**DOCUMENT 00 90 00
ADDENDUM**

ADDENDUM NO. [2] M Date: April 4, 2018

**RE: WITC – SUPERIOR CAMPUS
SUPERIOR INTERIOR AND EXTERIOR MAINTENANCE & REMODEL
600 N 21ST STREET
SUPERIOR, WI 54880
HSR PROJECT NO. 17063-1**

FROM: HSR Associates, Inc
100 Milwaukee Street
La Crosse, WI 54603
(608) 784-1830

2 MECHANICAL DEMOLITION PLAN - FIRST FLOOR
1/8" = 1'-0"

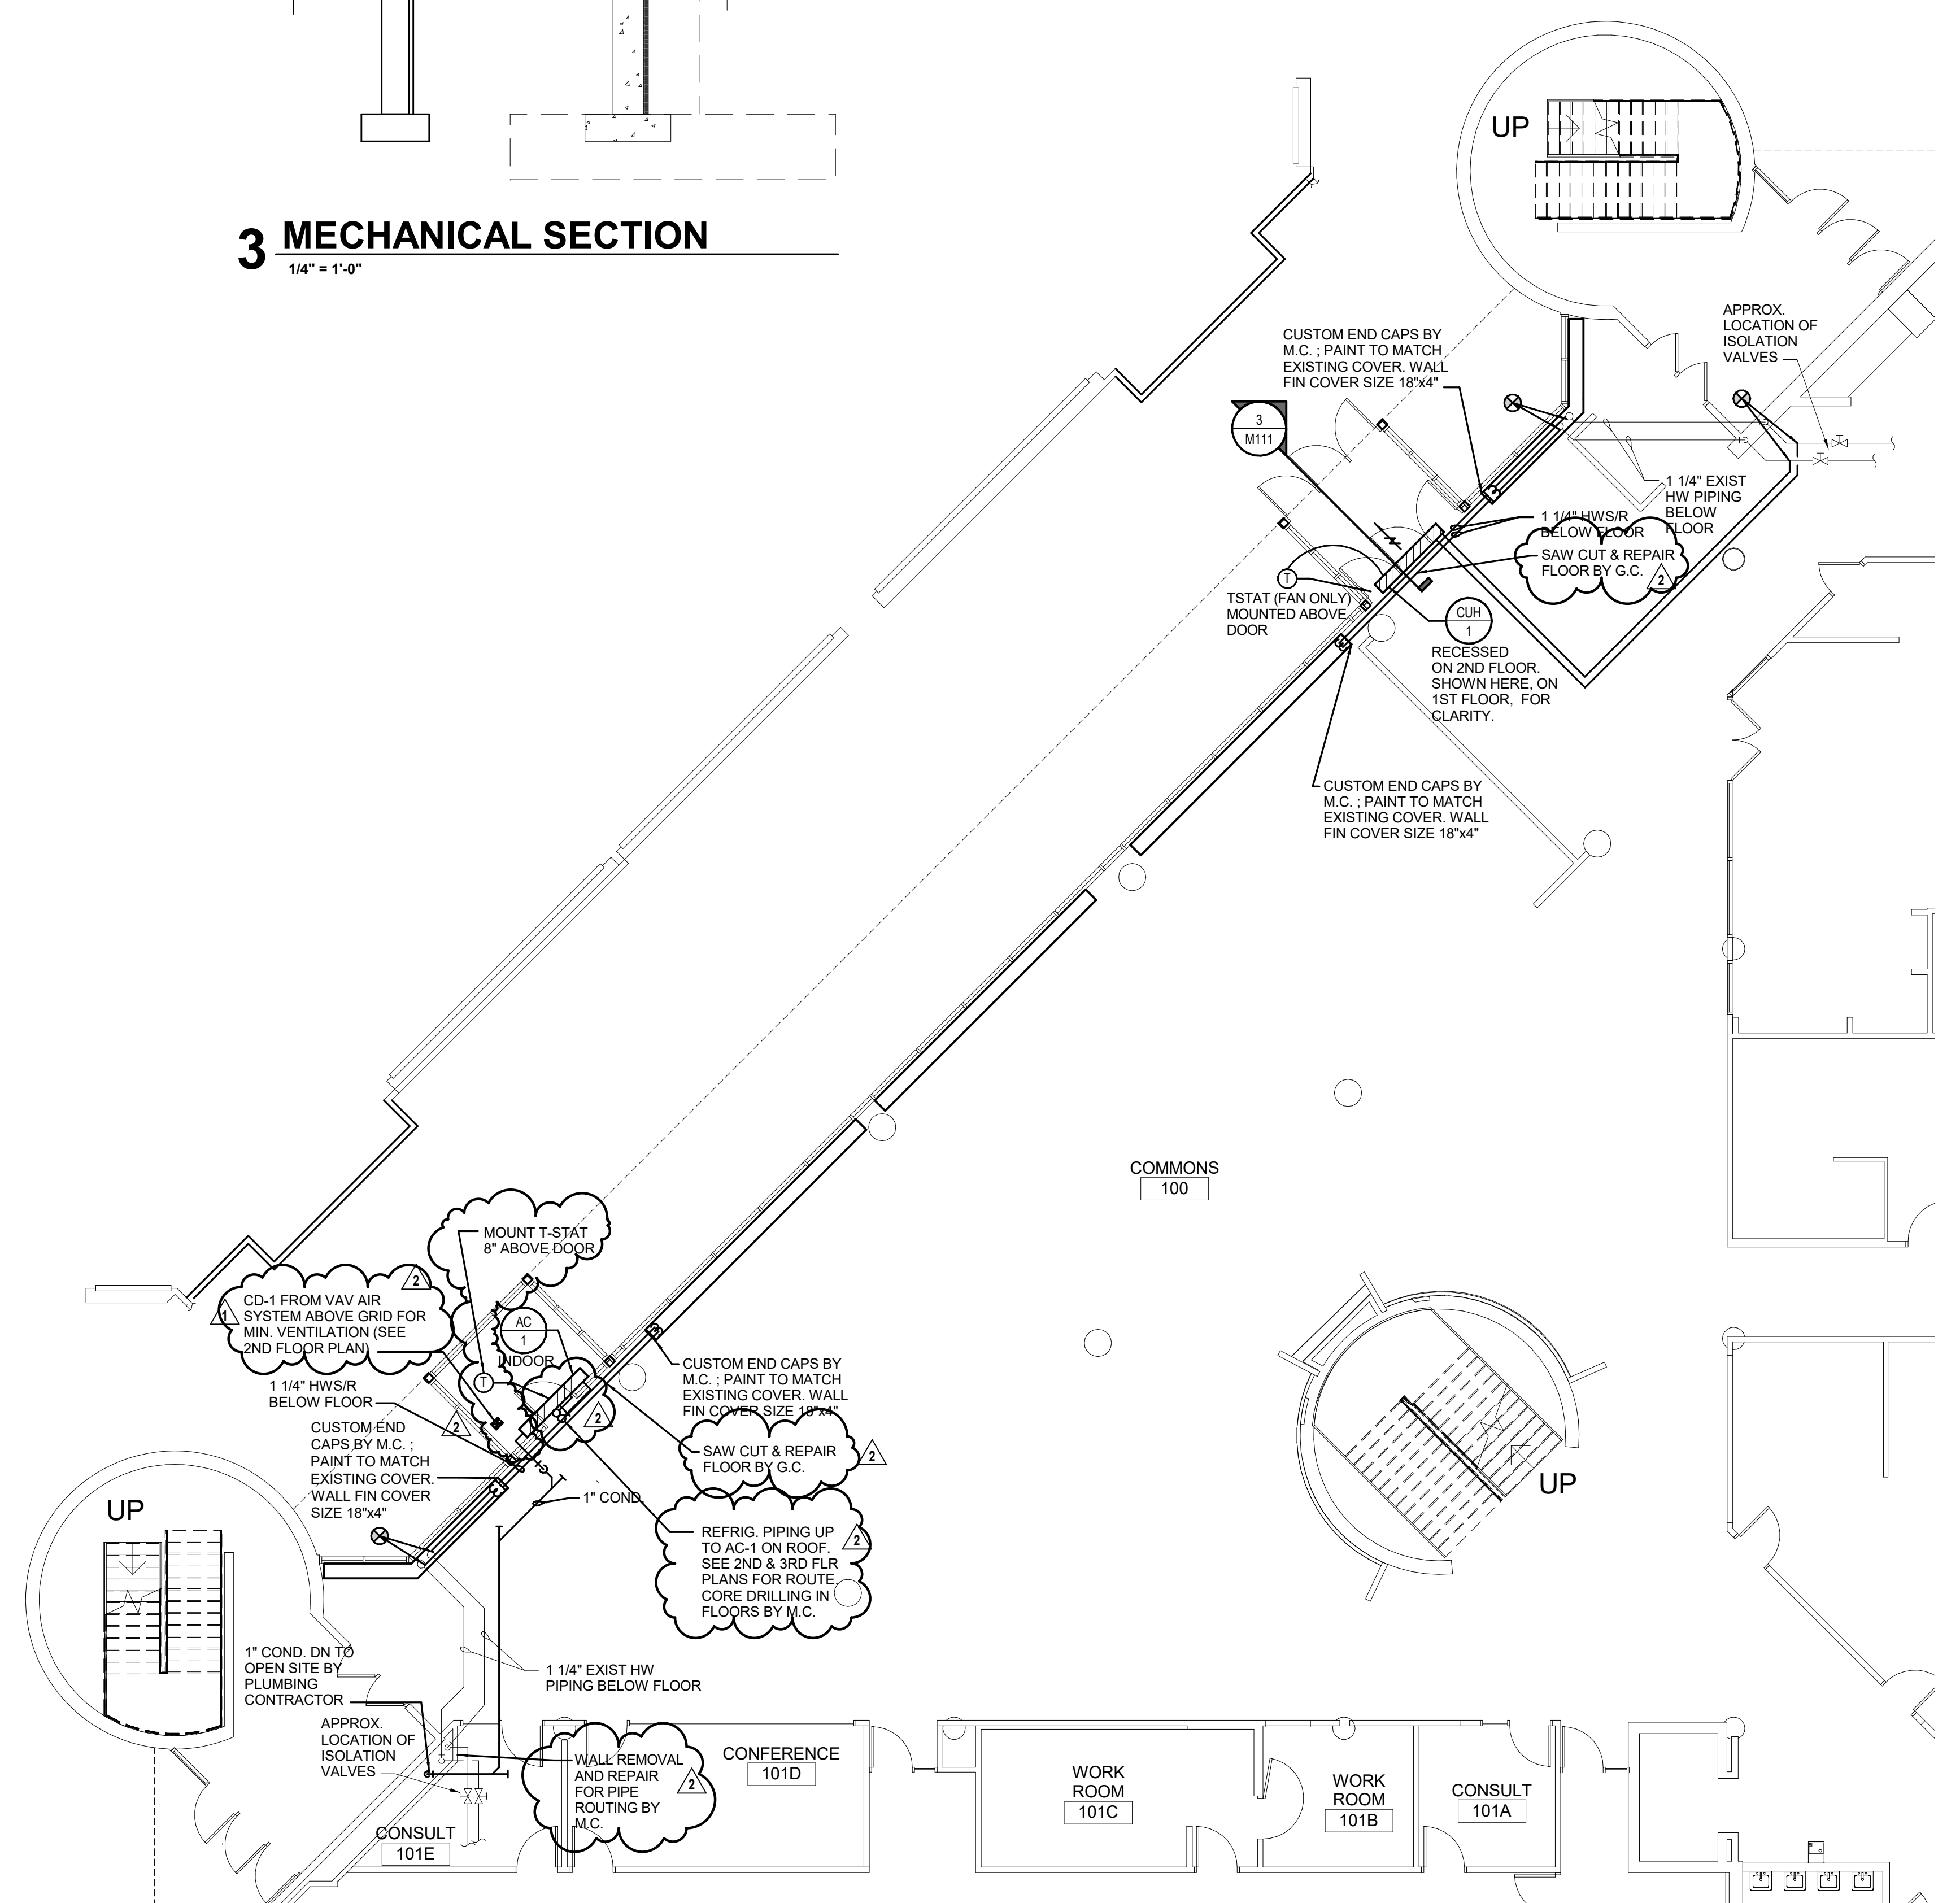
- a. Revisions clouded on Drawing.
17. Sheet S201R SECTIONS AND DETAILS 30 x 42 attached hereto
 - a. Revisions clouded on Drawing.
18. Sheet M111R MECHANICAL NEW & DEMOLITION PLANS – 1st FLOOR 30 x 42 attached hereto.

- a. Revisions clouded on Drawing.
 - b. Thermostat location for AC-1 clarified.
 - c. Pipe route for AC-1 refrigerant piping revised.
 - d. Clarification of cut and patch responsibilities for saw cutting, core drilling and chase removal.

M121R

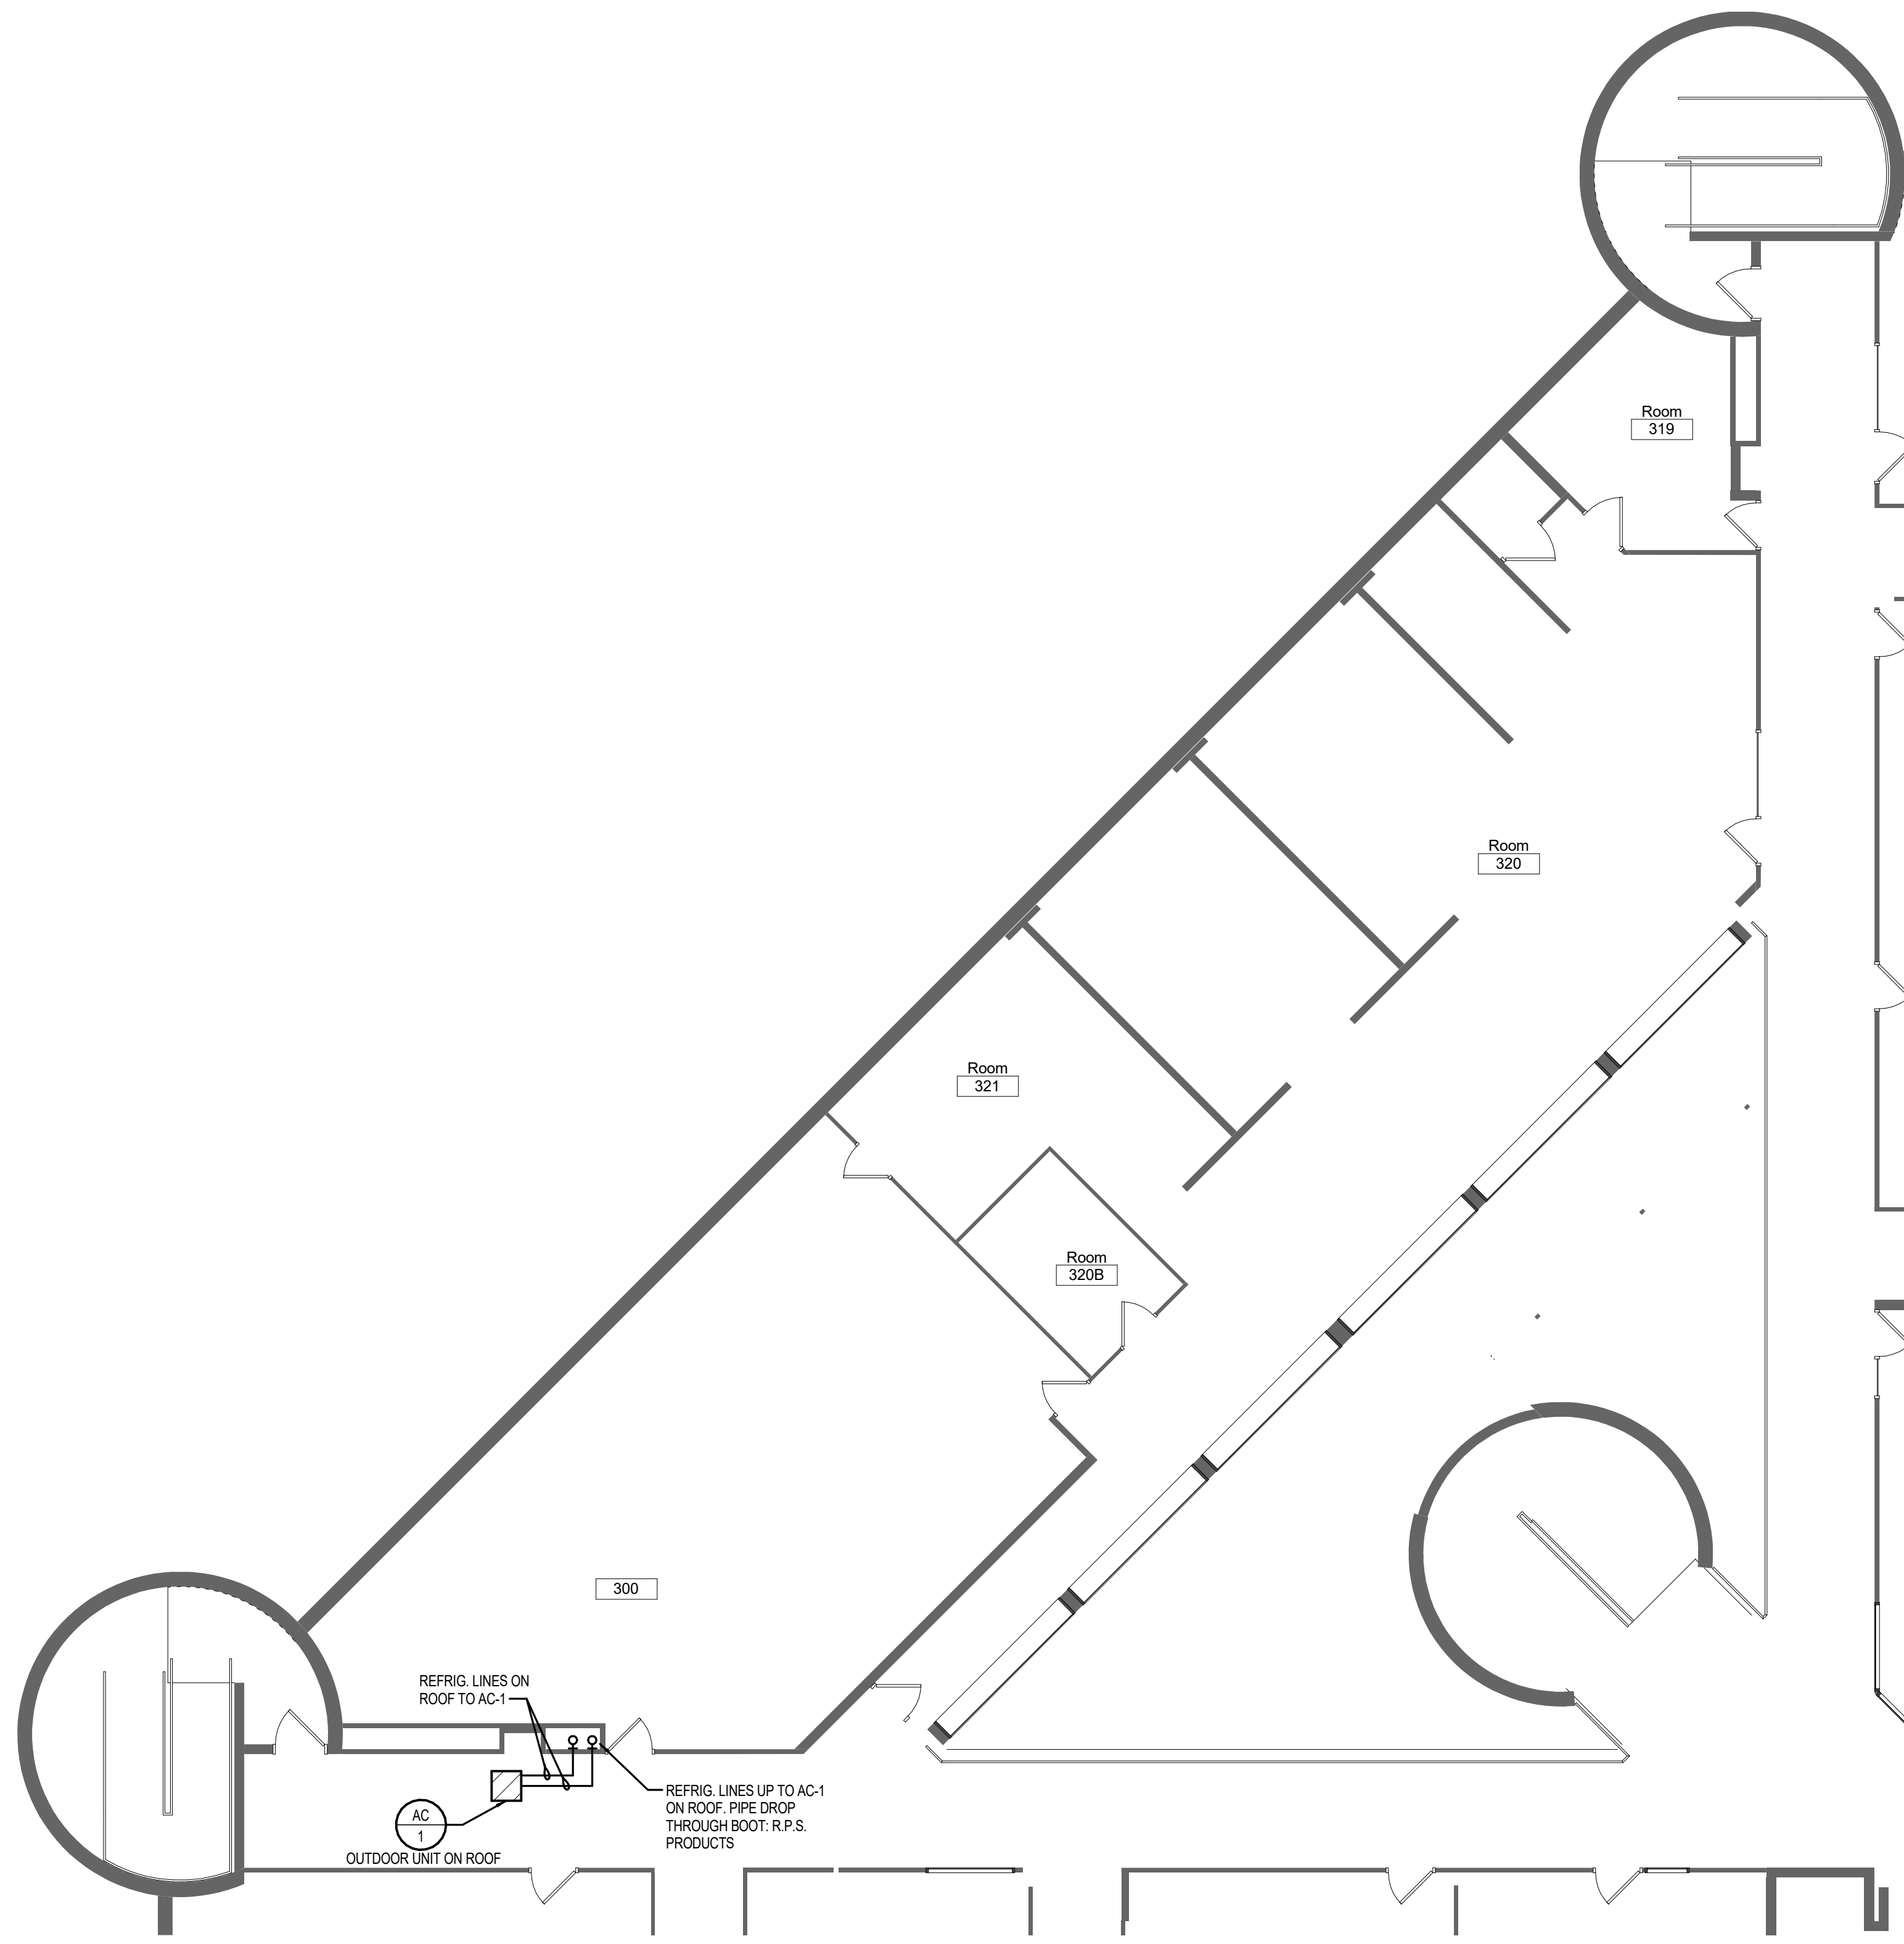
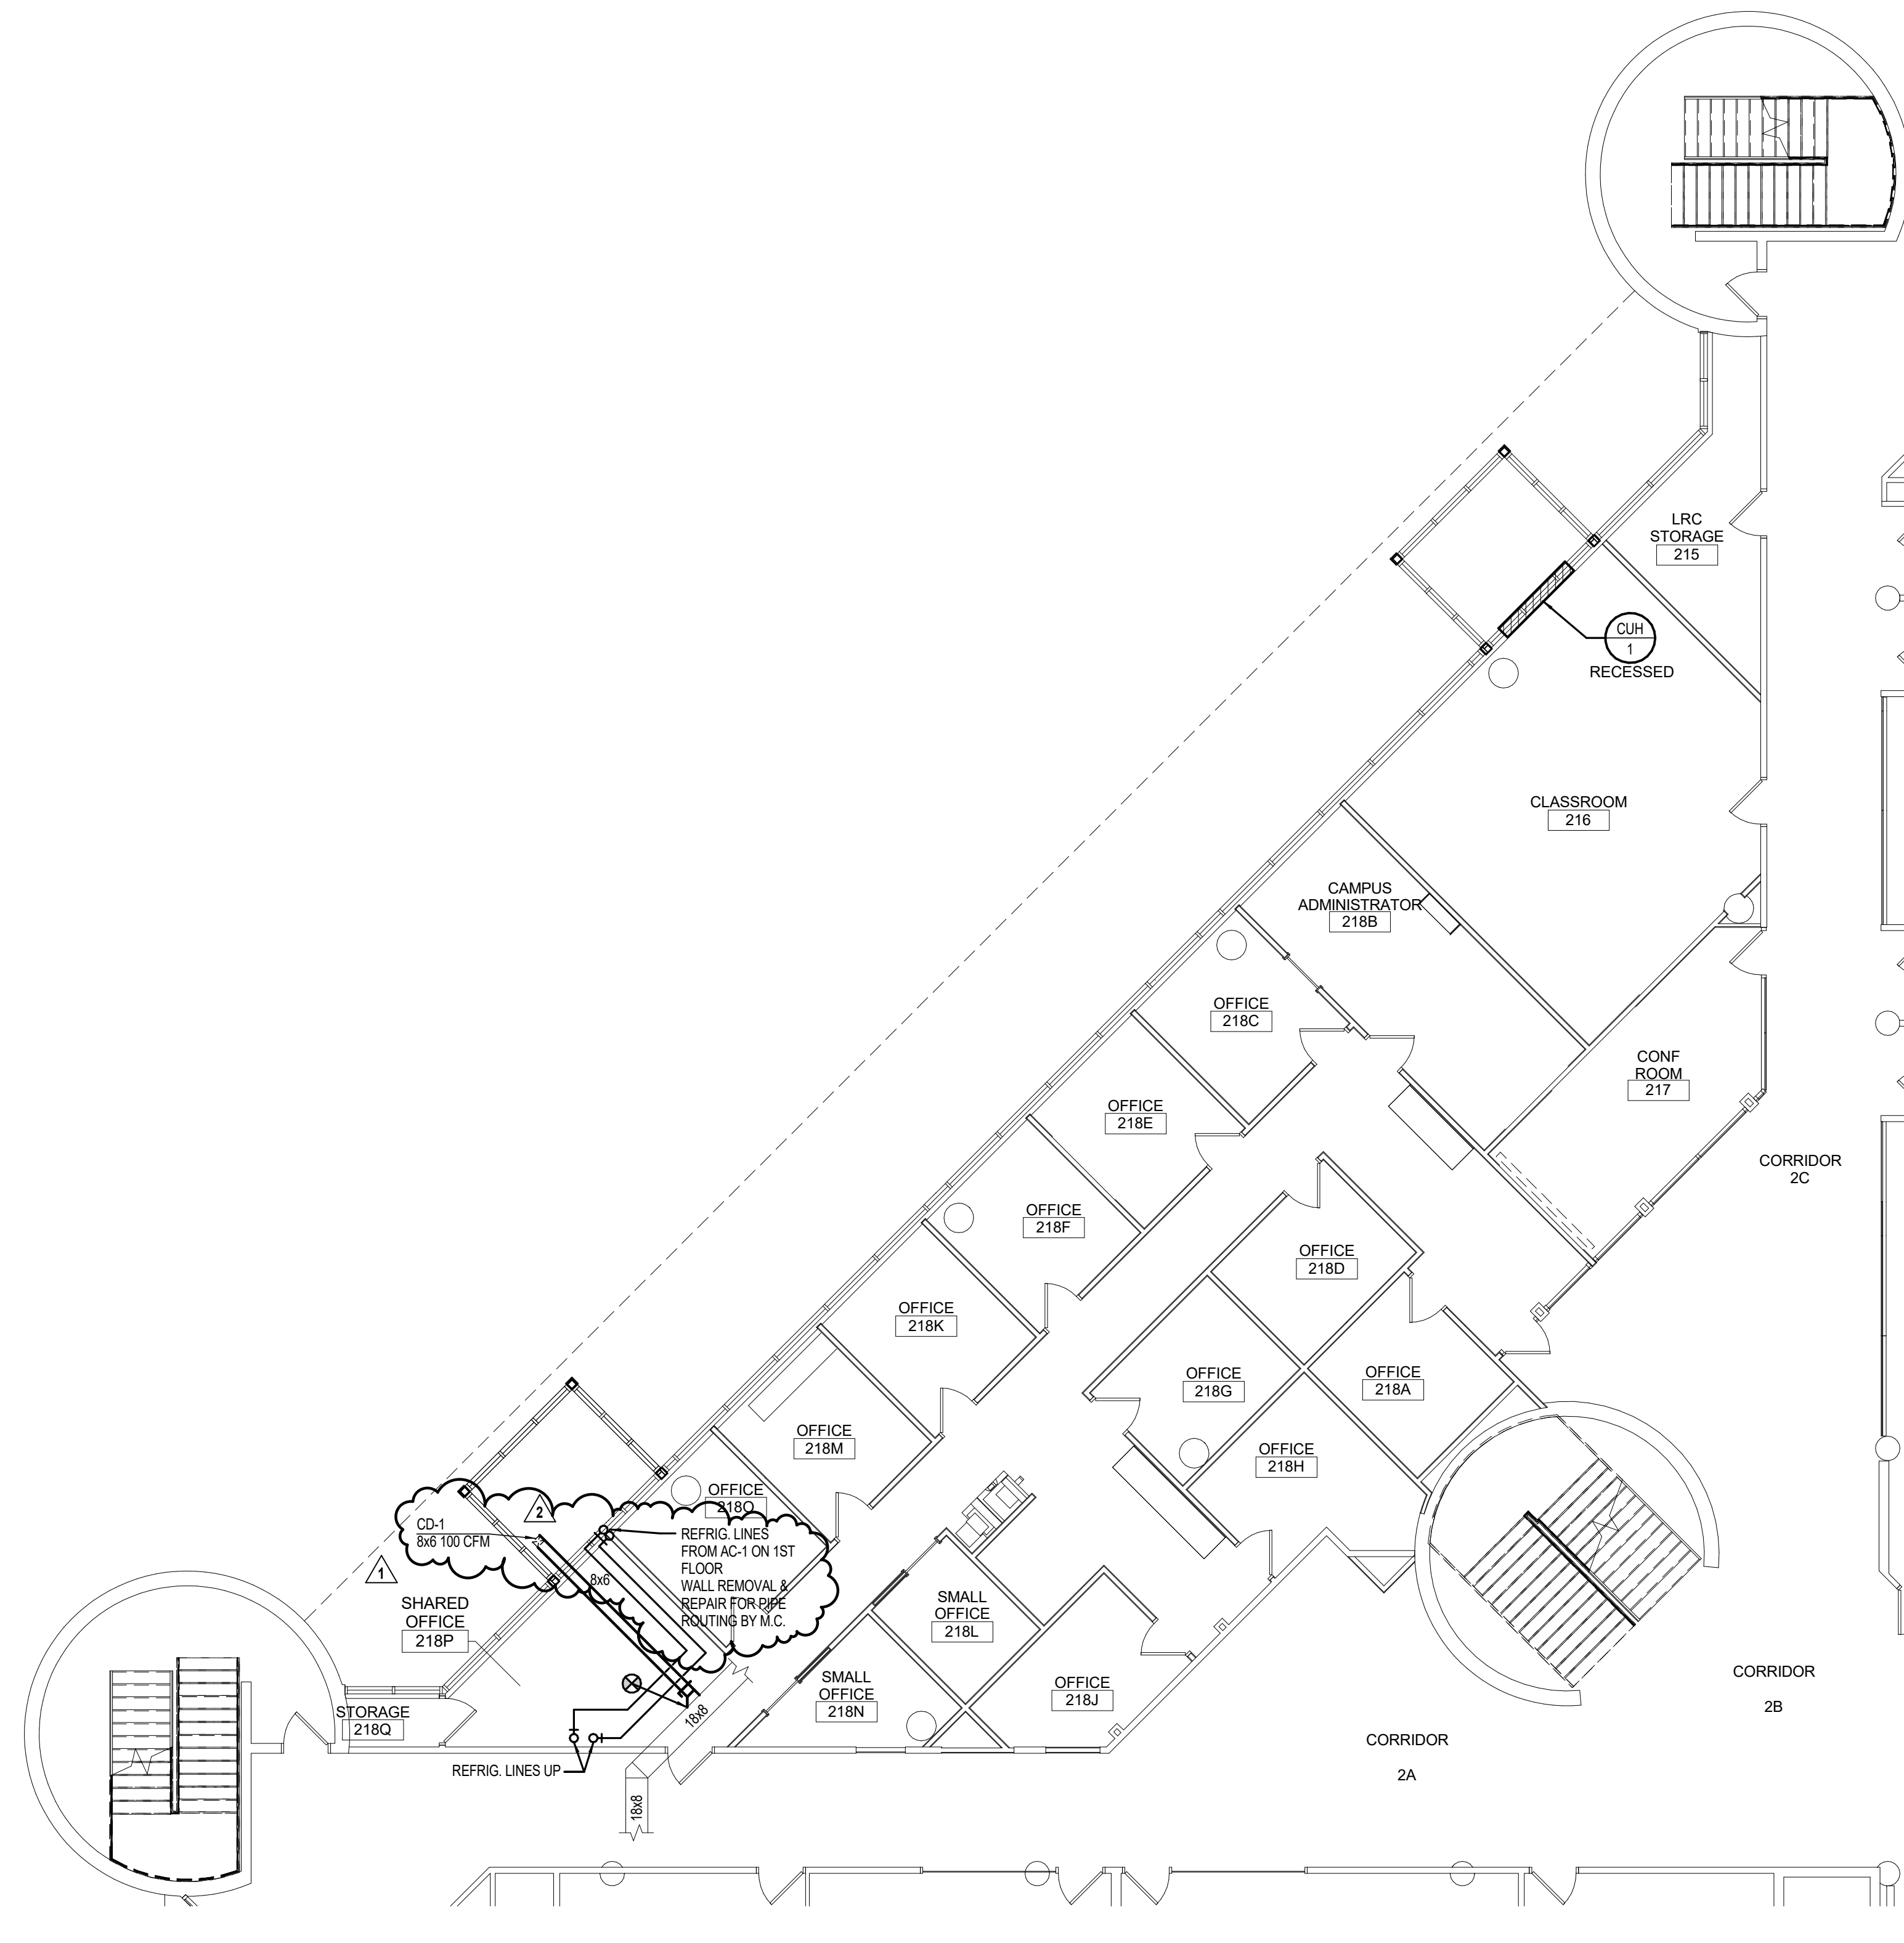
19. Sheet M121R MECHANICAL PLANS – 2nd & 3rd FLOOR 30 x 42 attached hereto
 - a. Revisions clouded on Drawing.
 - b. Pipe route for AC-1 refrigerant piping revised.

- c. Relocated SG-1 into ceiling space.
20. Sheet ED101R ELECTRICAL – DEMOLITION PLAN 30 x 42 attached hereto
 - a. Revisions clouded on Drawing.
 - b. Existing light fixtures to remain added to plan.
